Release 1: Original release

DRIVER'S ANTI-GLARE SHIELD INSPECTION AND REPLACEMENT Prevost vehicles

Figure 1

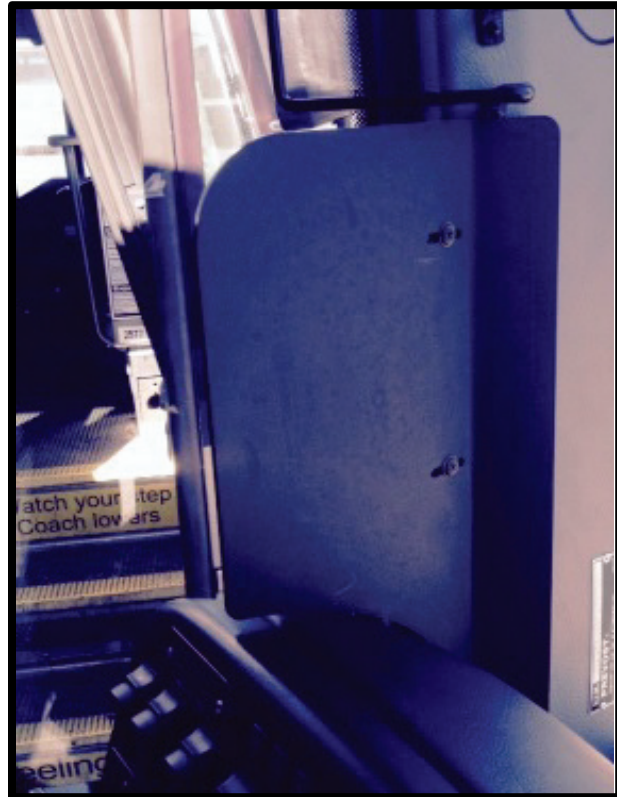
- 1) In the driver's area, on the left windshield post, besides the Speakeasy control head, inspect the Plexiglas glare shield to determine on which face the matte finish is located.
- 2) Glossy finish should be on road (windshield) side while matte finish should be on curb (coach interior) side.
- 3) Refer to Fig. 1 and use bottom view to help identify proper matte finish side.
- 4) If matte finish is on the (road / windshield side) side of the anti-glare shield, replace with a new #382580 part.
- 5) Confirm matte and glossy finish faces are as shown in fig.1 before installing new part.
